# June 2022 Product Shipping Configuration Change Notice For Poly VVX Phones

Engineering Advisory 210826

September 2022 | 3725-47130-013E

## Example VVX 350 Console Label and Revision Code

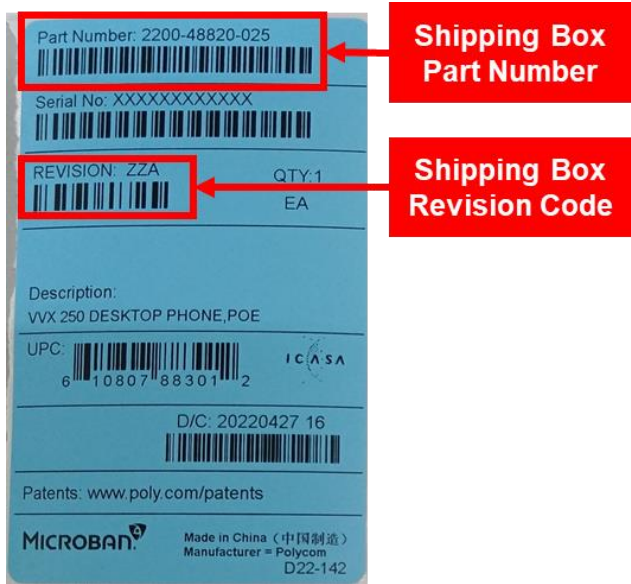
You can determine whether your phone includes the new hardware changes and software by examining the color of the shipping label, the part number and console revision listed on back of the phone, and the part number and console revision listed on the shipping boxes, as shown in the following figures.

### Example VVX 450 Web Configuration Utility

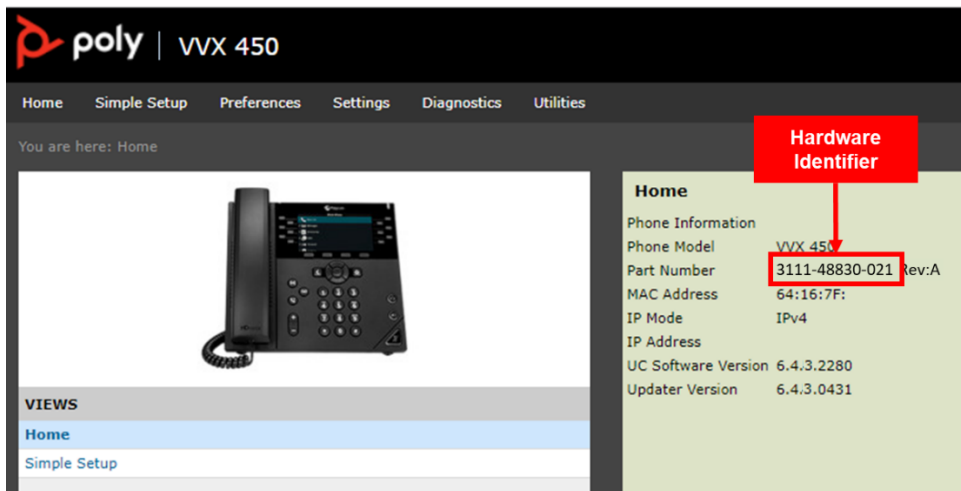
You can also identify a phone with the new hardware revision by examining the Hardware Identifier displayed in the phone's Web Configuration Utility and Phone UI as shown in the following figures.
